8. Well Name and No.
PLU BIG SINKS 11 FEDERAL 1H9. API Well No.
30-015-3714710. Field and Pool, or Exploratory
WILDCAT-BONE SPRING11. County or Parish, and State
EDDY COUNTY, NM**SUBMIT IN TRIPLICATE - Other instructions on reverse side.**

Chesapeake, respectfully, requests permission to change the rig plat to the Latshaw Rig #6. Pad size 275' X 330'.

Rig Plat attached.

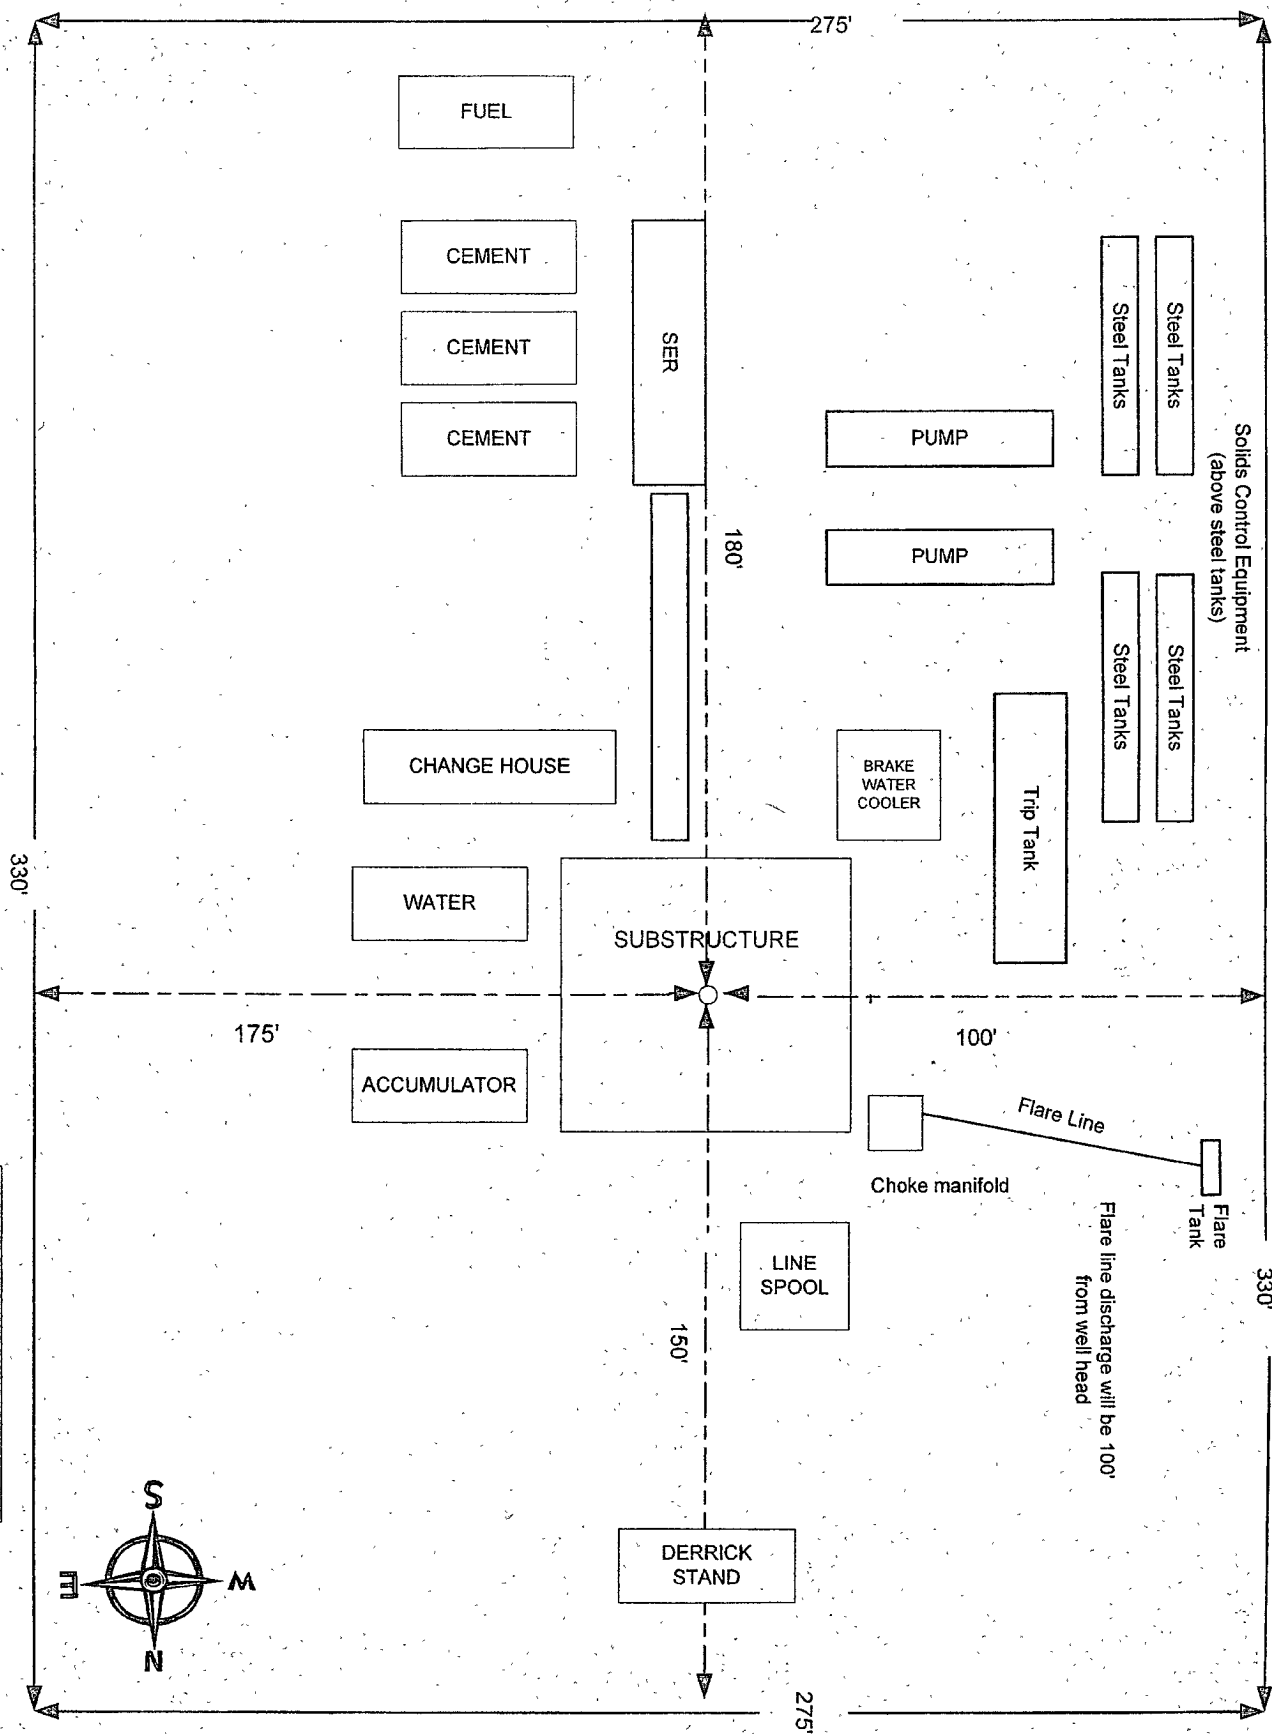
Due to drop-off in contour to the north and west, the larger pad size submitted under the Sundry Notice, submitted 10/07/09, will only fit if the location is turned.

V-DOOR NORTH. RESTRICT PAD SIZE TO THE NORTH AND WEST NOT TO EXCEED 150 FT.
